UNITED STATES PATENT AND TRADEMARK OFFICE

APPLICATION NO.	FILING DATE	FIRST NAMED INVENTOR	ATTORNEY DOCKET NO.	CONFIRMATION NO.
09/521,037	03/08/2000	Pawan R. Gupta	MOF-11	1918
22855	7590	04/07/2003		
RANDALL J. KNUTH P.C. 3510-A STELLHORN ROAD FORT WAYNE, IN 46815-4631			EXAMINER MARTIR, LILYBETT	
			ART UNIT 2855	PAPER NUMBER
			DATE MAILED: 04/07/2003

Office Action Summary

DETAILED ACTION

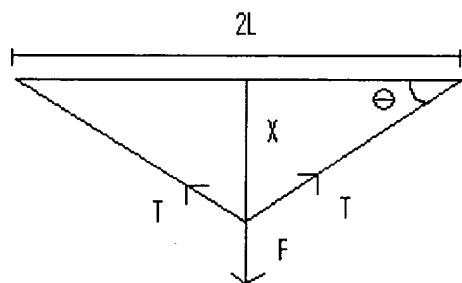
6. Claim 10 is rejected under 35 U.S.C. 103(a) as being unpatentable over either Kamabashi or Proceq SA.

7. It can be found from simple mathematical calculations utilizing the commonly known SOH- CAH- TOA and commonly known physics equations for Tension that when a string of length $2L$ is stretched between two fixed points with a tension T and force F is applied at mid span normal to the string, where the string deflection under the force is x , that a relation between F and x/L exists, assuming that T remains constant even though the string is stretching and that the displacement x is small relative to the string length. (consider equilibrium of the midpoint of the string where the force F is applied). At this point we have three forces acting; the tension in the string on either side of the point and the force F . Now, assuming the displacement of the center of the string is small relative to the string length, the angle of the string is simply the slope of the string.

Therefore it can be concluded by equating forces that:

8. Kamibayashi and Proceq Sa disclose the measurement of tension in a wire that is being deflected but they fail to disclose the involved equations utilized in said process. It would have been obvious to one of ordinary skill in the art at the time the invention was made to utilize commonly known physics and mathematical equations such as the ones disclosed above to further obtain reliable values that are both accurate and reliable.
